REMARKS

09/678,414

APPENDIX A

Two Sheets of Annotated Marked-Up Drawings

FIG. 3C 3D

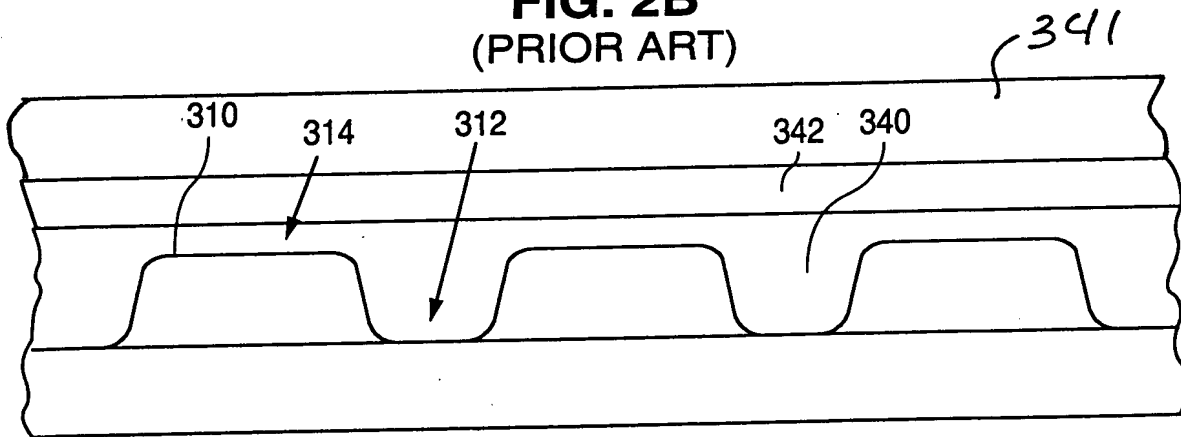
Applicant requests the Examiner's permission to amend the drawings as shown in red on the attached two sheets of annotated marked-up drawings. The annotated marked-up drawings, which are attached as Appendix A, changes FIG. 3C to FIG. 3D, adds a mask 341 in new FIG. 3D, and adds a new FIG. 3C that illustrates the formation of mask 341 on planarized polysilicon layer 340. In addition, two replacement drawing sheets that include the changes are attached in Appendix B. Further, the specification has been amended to reflect the reference numerals.

The Examiner objected to the amendment mailed on March 15, 2002 under 35 U.S.C. §132 as introducing new matter into the disclosure. In objecting to the amendment, the Examiner indicated that there is support for the formation of a layer of third material over a planarized layer of material, but argued that there is no support for a layer of material 342 that lowers resistance.

"As shown in FIG. 3D, a layer of material 342 is formed over planarized polysilicon layer 340." (See the fifth paragraph of page 5, as amended above.)

The phrase "that lowers resistance" has been deleted. Thus, from what applicant can determine, no new matter has been introduced into the disclosure.
